RE: DR-10-08 West Linn High School

WEST LINN HIGH SCHOOL
Class I Design Review
June 21, 2010

Project No.: 10884-09007 Project Name: WLHS Baseball Seating
To: Khoi Le, P.E., City of West Linn
From: Patrick Tortora, P.E.
Copies To: M. Wharry, P.E.
Subject: Stormwater Drainage Design Memorandum

WL-C0

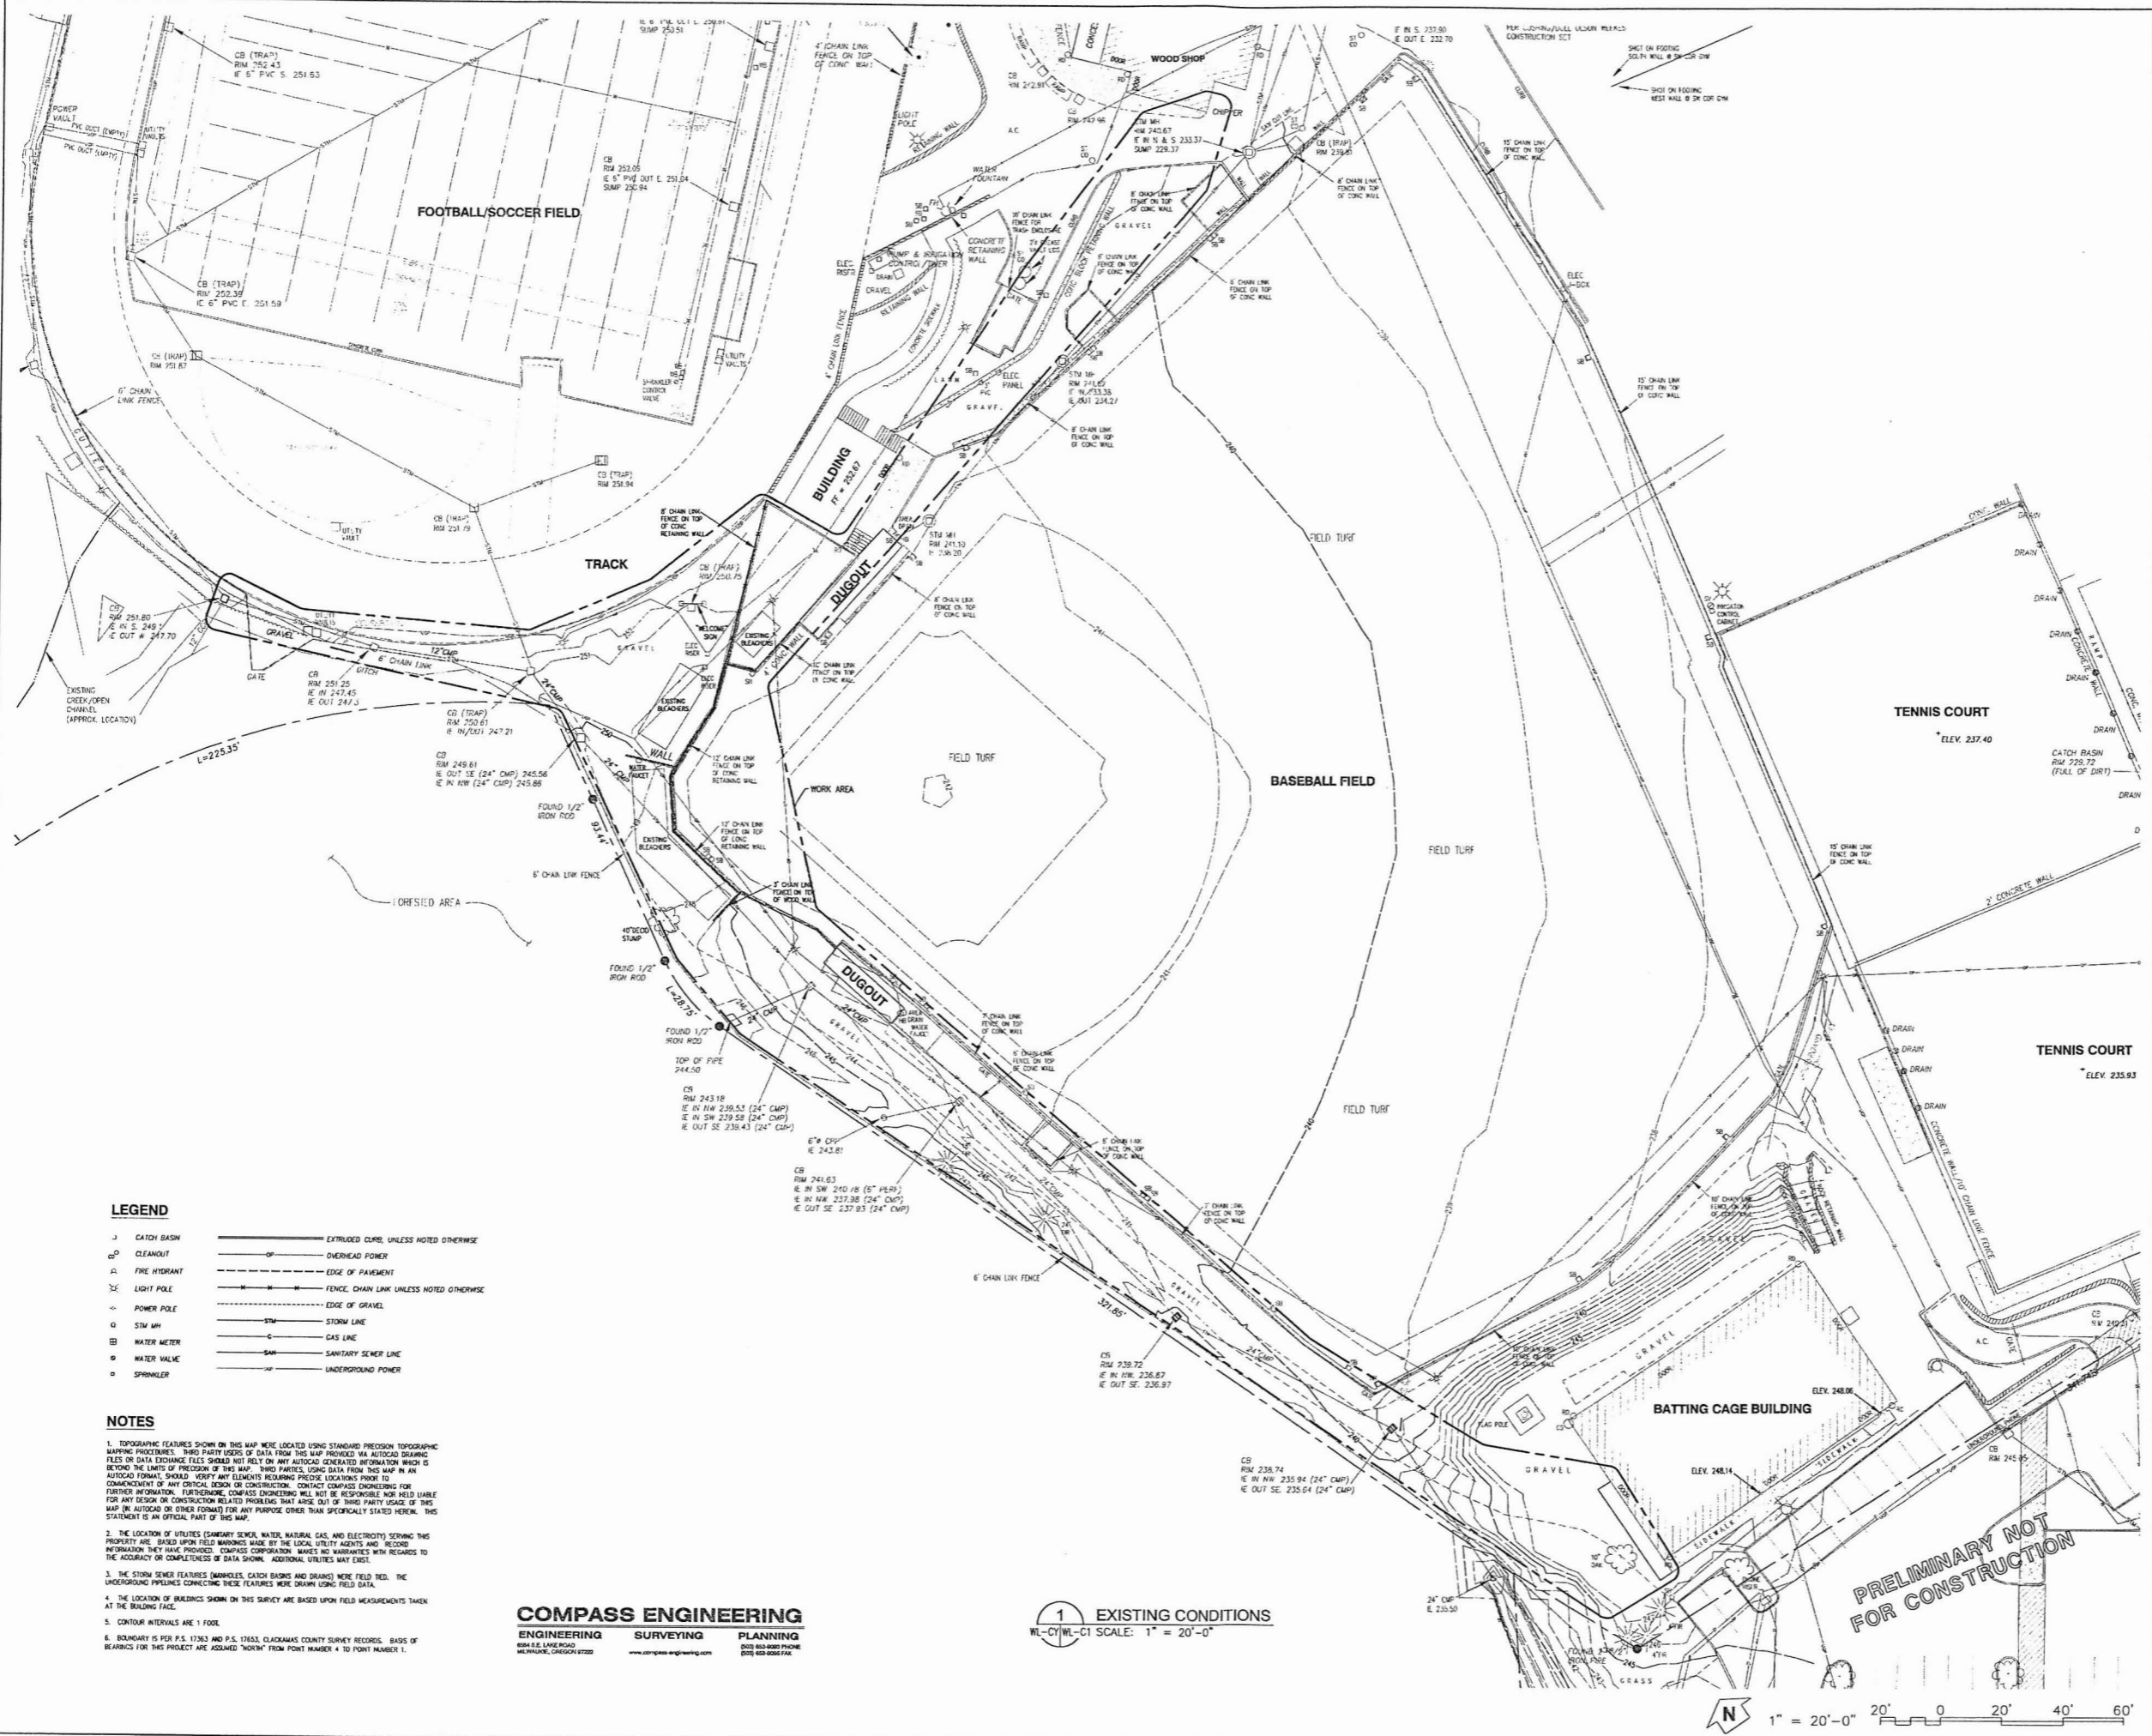
- **55.120(H)(3)** - The application narrative includes a waiver to this requirement because the trash disposal and recycling areas are some distance from the proposed improvements, and they will not be changed or affected in any way by the baseball field and track improvements. The location of the existing facilities is shown on Sheet WL-C0.

Therefore, showing the improvements and easements on this portion of the school site is not relevant to the scope of this application. To provide context, the existing conditions sheet (WL-C0) shows the location of adjoining properties.

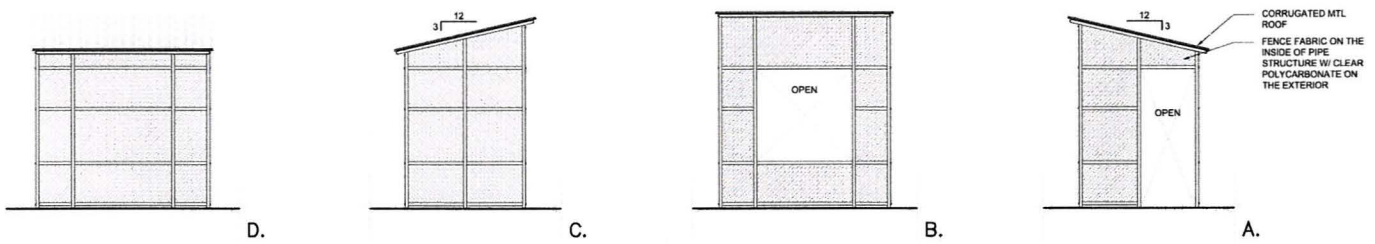
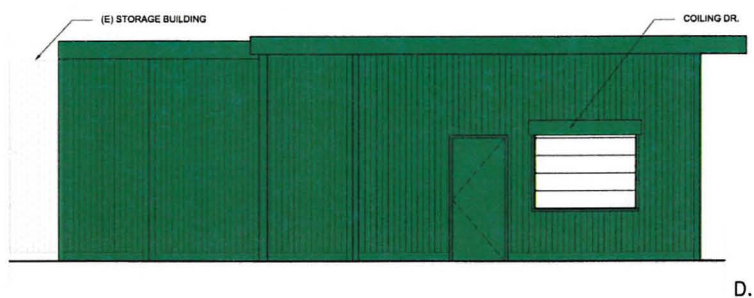
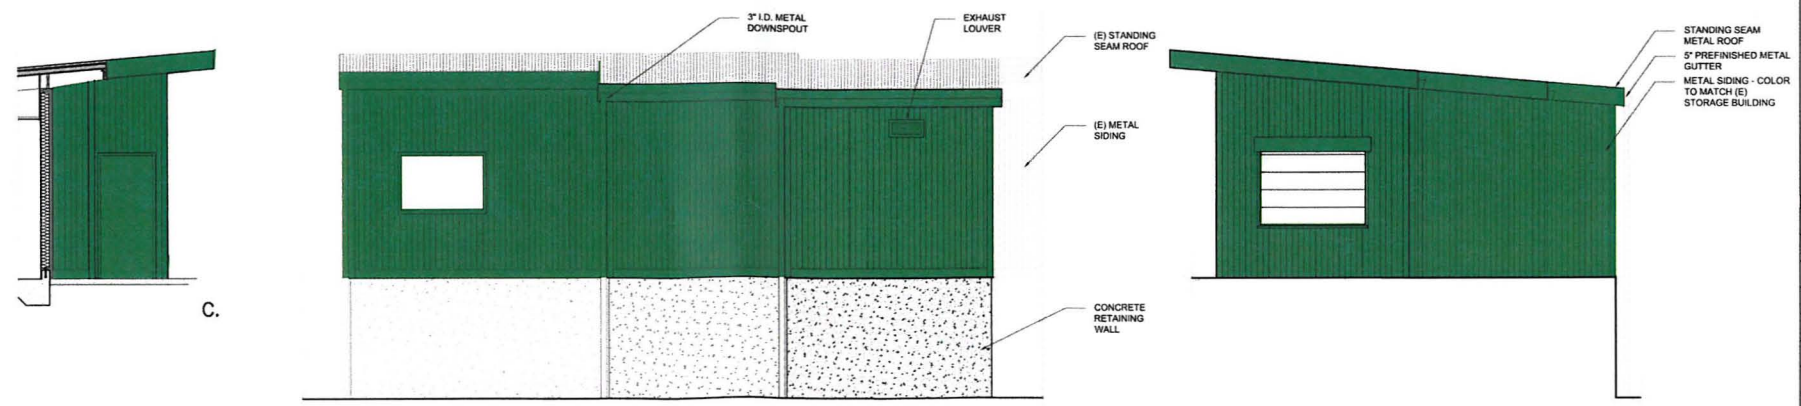
- **55.070(E) and 55.140(B)** - An exterior color sample is provided, and the proposed building color is now shown on Sheet A3.00. The exterior color for the storage building restroom/concession addition and announcers booth will match the color of the existing storage building.
- **55.120(C)** - The civil plan sheets have been modified to make the contour elevations more legible at the 11X17-inch size. As noted above, a revised set is attached.
- **55.120(D)** - The stream location is shown on Sheet WL-C1 plus other civil sheets.
- **55.120(F)(2)** - The tree conservation easement is shown on Sheet WL-C0.
- **55.100(A)(1)** - Responses to the applicable review criteria in CDC 33.040 are included in the application narrative.
- **55.100(B)(6)(j)** - A response to this criterion is included in the application narrative.

West Linn High School (DR-10-08)
Building Finish Material and Color Sample
To match existing (see Sheet A3.00)
